ADDRESS: 1108 S FRONT ST

Proposal: Legalize addition and roof deck

Review Requested: Final Approval

OVERVIEW: Between December 2023 and March 2024, a significant addition was constructed at the rear of 1108 S. Front Street without a building permit or the Historical Commission's review or approval. The Historical Commission did approve interior demolition and make-safe permit applications in August and December 2023, respectively, but those permits did not cover the new construction. When a Historical Commission staff member visited the site, he saw that the unpermitted addition was under construction despite a Stop Work Order issued by the Department of Licenses and Inspections on 9 February 2024. A similar application for legalization was reviewed by the Architectural Committee and Historical Commission earlier this year, which was denied pursuant to Standards 9 and 10.

rear elevation

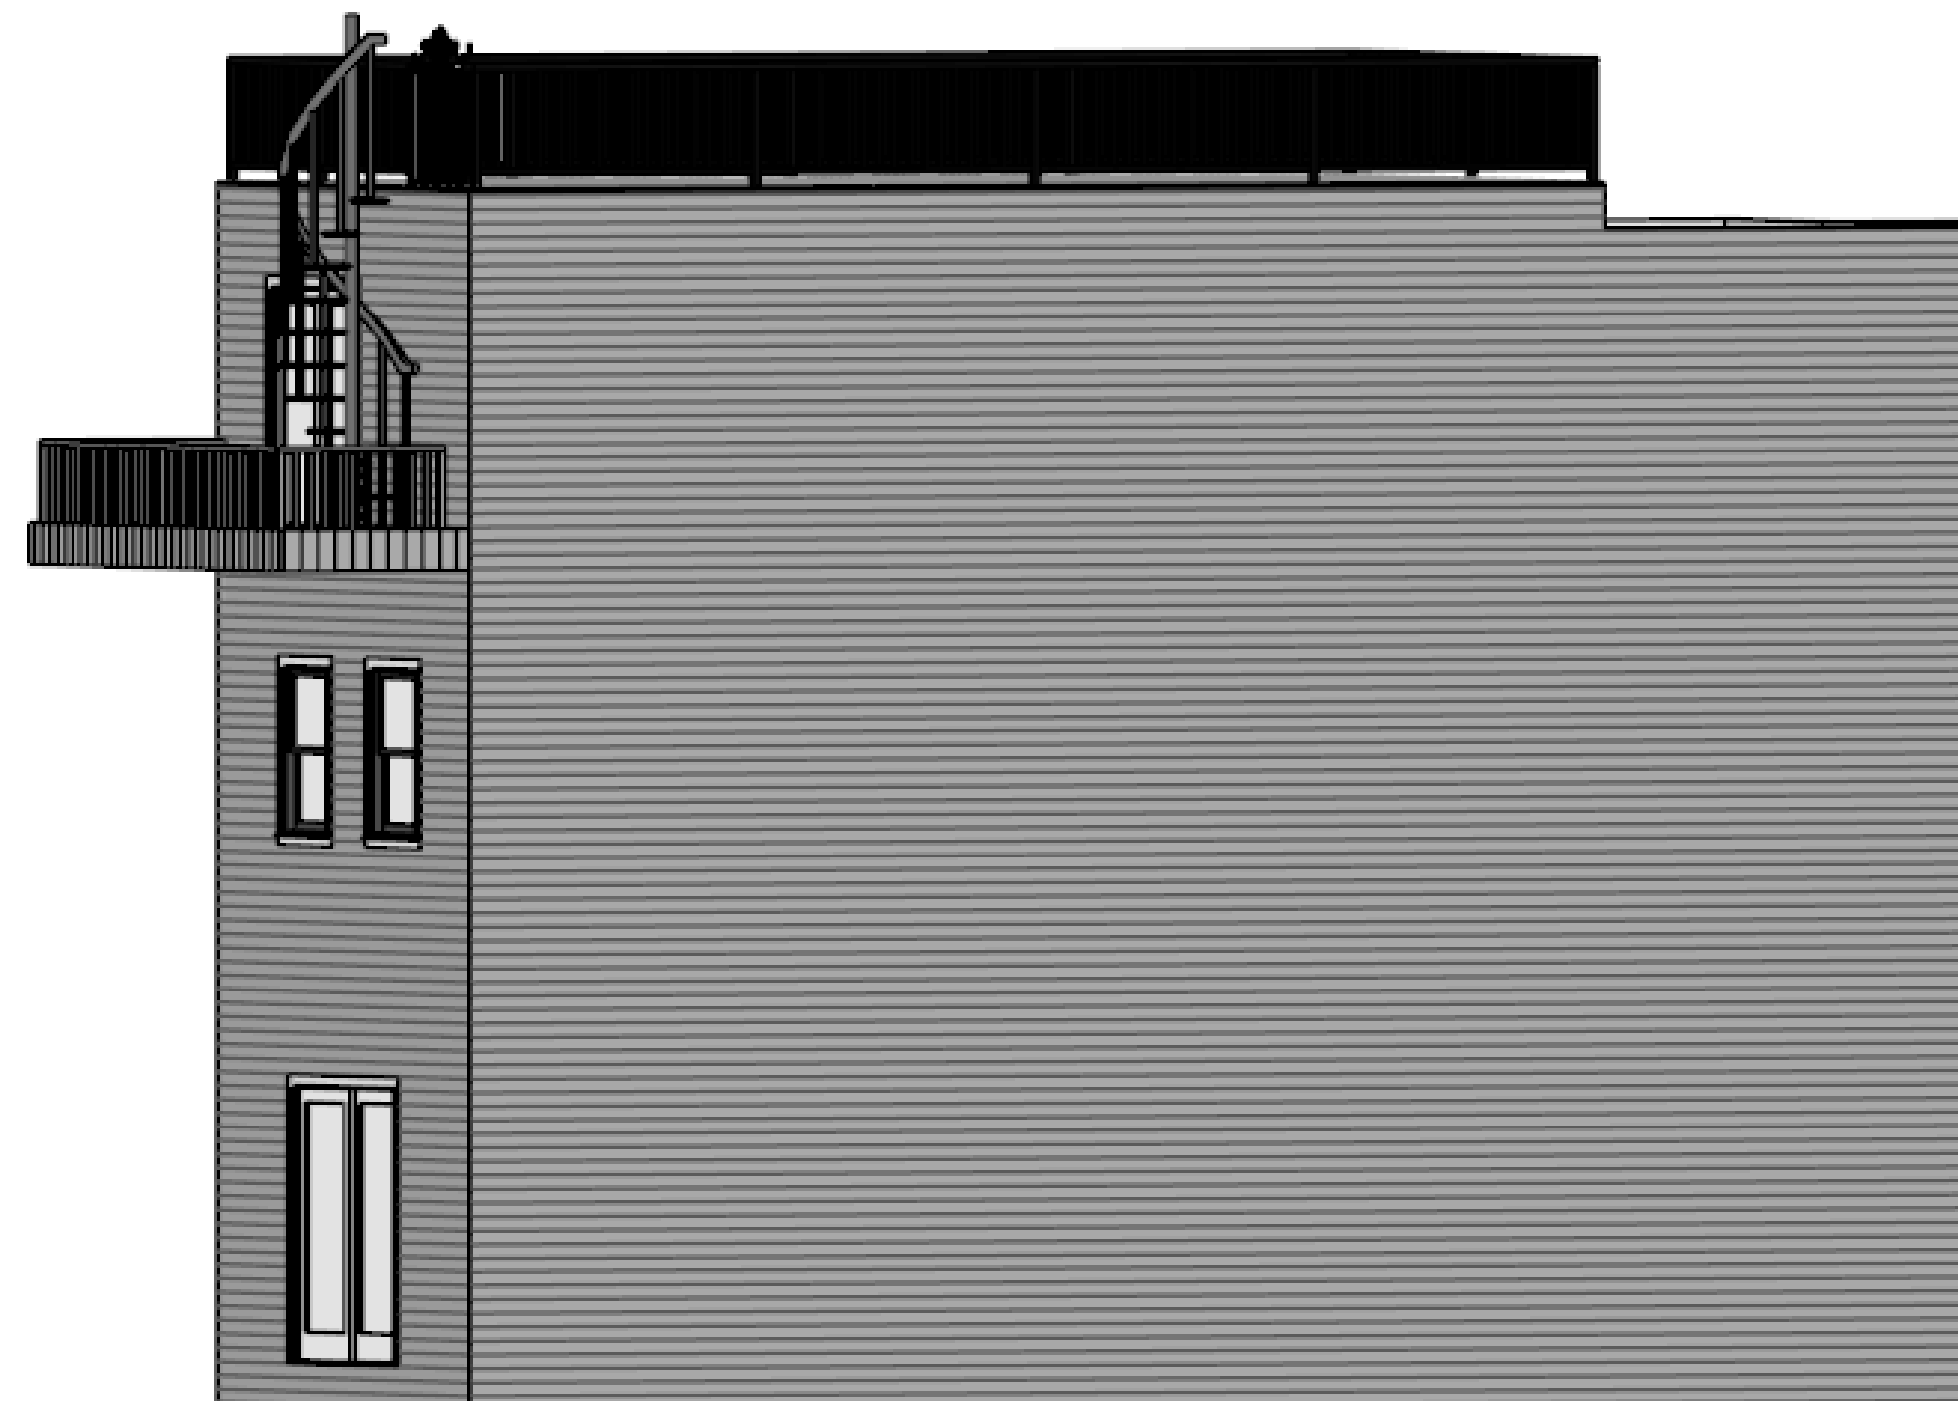
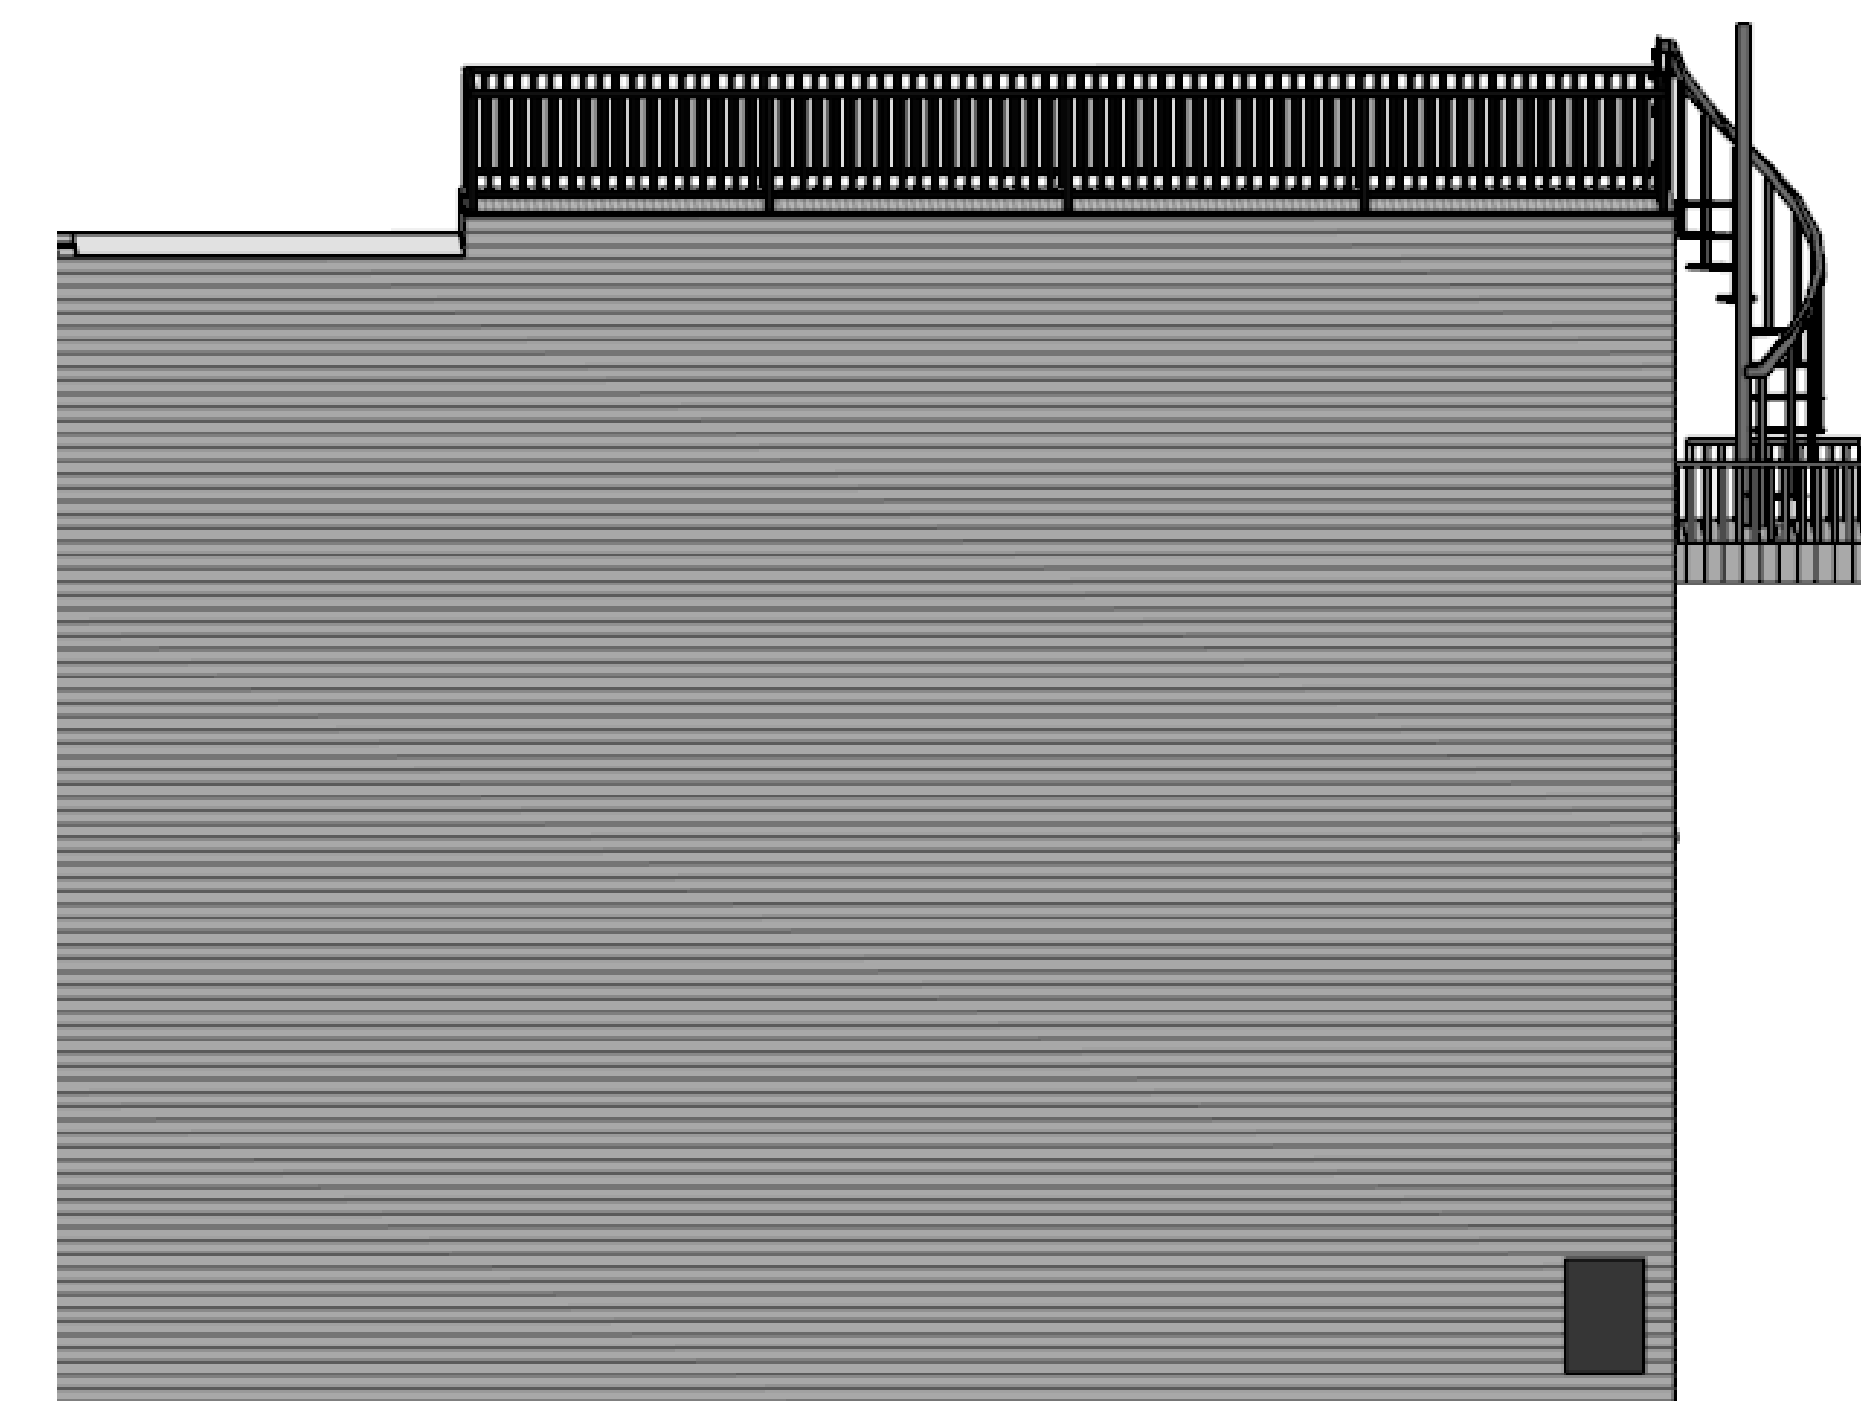
This new application includes elevation views of the addition and proposes a rear balcony and spiral stair to replace the pilot house which was constructed without Historical Commission approval. This application also proposes replacing the solid wall around the roof deck with a black metal railing. Current photographs show removal of front façade windows and alteration of the front dormer and cornice, for which restoration details are not provided.

- The rear addition is very large in comparison to the historic structure. Removing the pilot house is an improvement, but the roof deck is still very visible from the public right-of-way and changes the established spatial relationships of the property.

- A two-story addition with a roof deck on the rear ell rather than the main block may be able to satisfy this Standard.
- *Standard 10: New additions and adjacent or related new construction will be undertaken in such a manner that, if removed in the future, the essential form and integrity of the historic property and its environment would be unimpaired.*

second floor

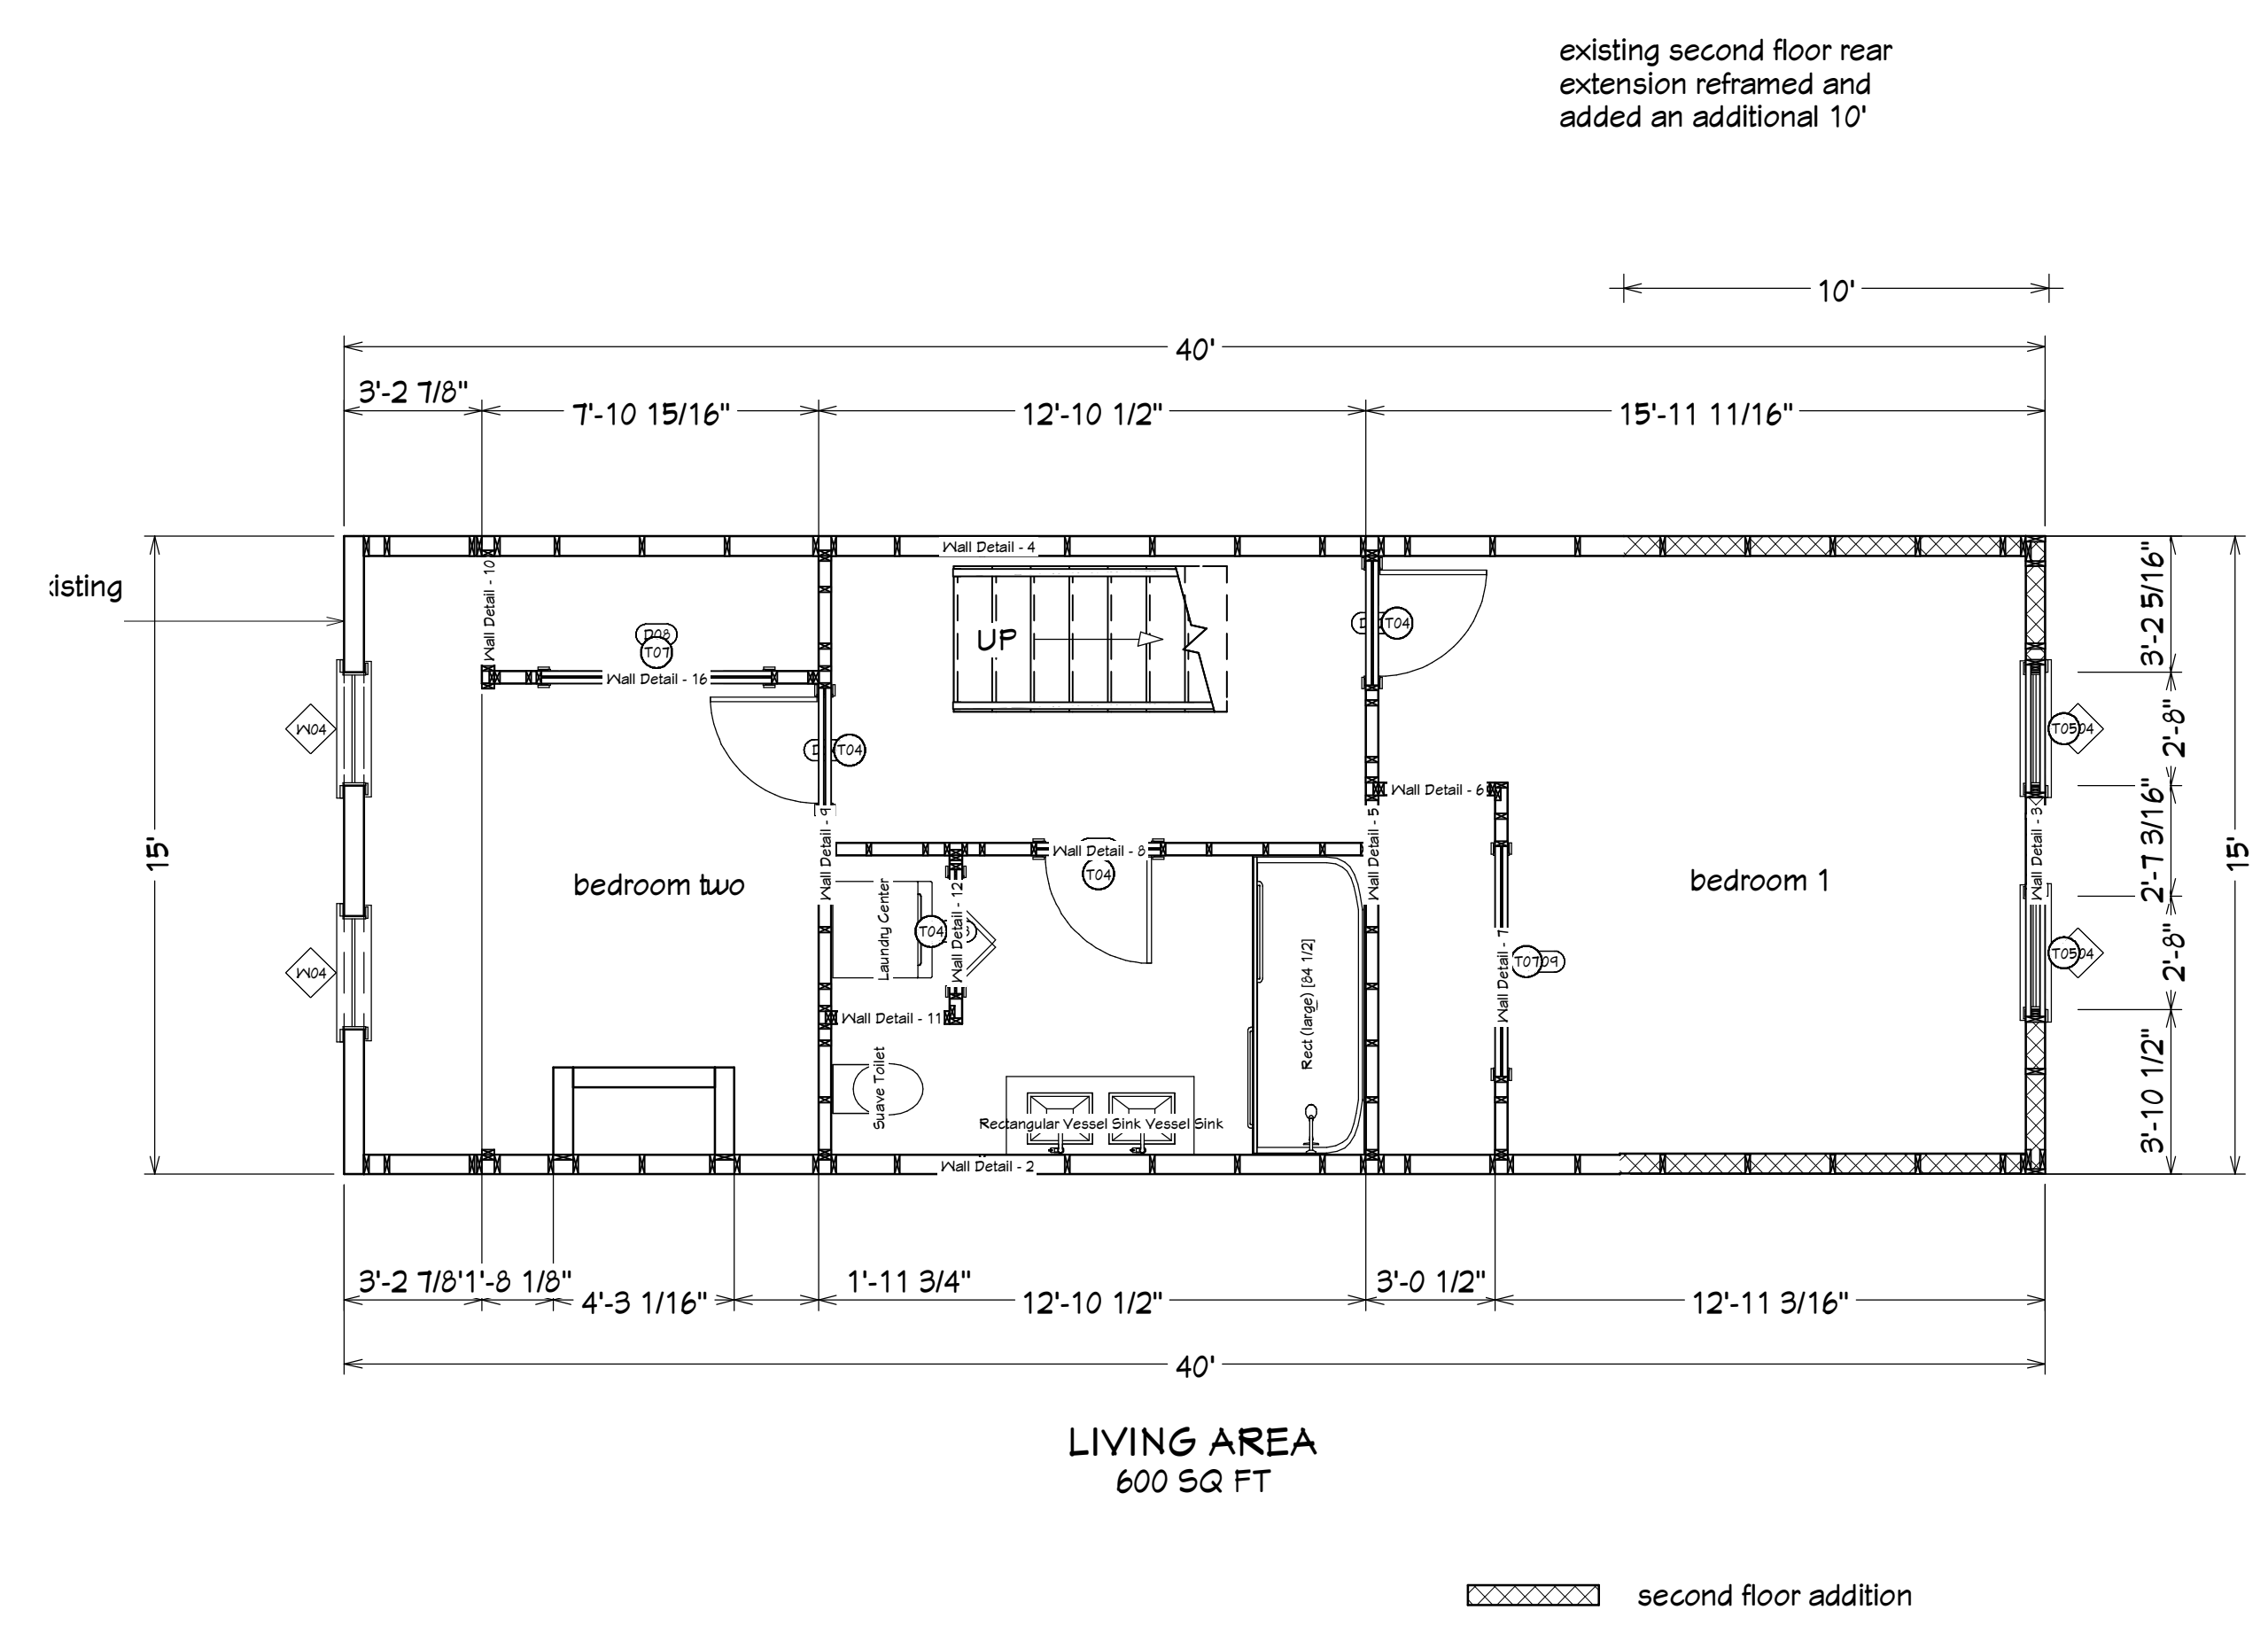
- From the submitted floor plans, it appears that at least some of the existing rear walls were demolished without the Historical Commission's approval.
